Access Report

Medical Consultation Rooms
5 Vidler Avenue
WOY WOY NSW

For: Landmark Homes
Ref: LP_22347

Development application documentation for the proposed Medical Consultation Rooms located at 5 Vidler Avenue Woy Woy, has been reviewed against current accessibility legislation.

Figure 2 | Overall Site Plan

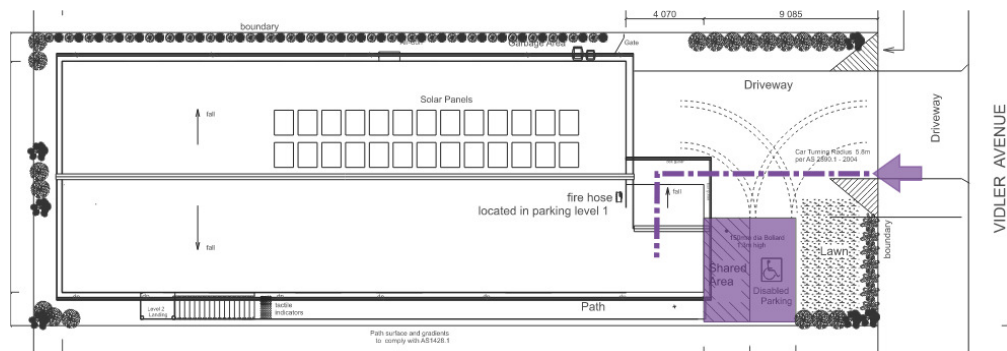
An accessible path of travel is provided to the building entrance (lift) from the allotment boundary along Vidler Avenue via the driveway area.

On grade access is available between the accessible car parking and the building entrance (lift).

Carparking is provided at Level 1. Plans show a total of ten (10) carparking spaces including one (1) accessible space.

The overall configuration of the accessible carparking achieves compliance with current legislation including dimensions, chevron markings and provision of a bollard.

Stairs are provided as a part of the pedestrian access from Vidler Avenue and the carparking area to the building entrances (public and staff entrances respectively).

The overall configuration of each stair achieves compliance with current legislation including handrails both sides and tactile indicators top and bottom.

Ensure provision of handrail extensions and contrasting non-slip nosing strips.
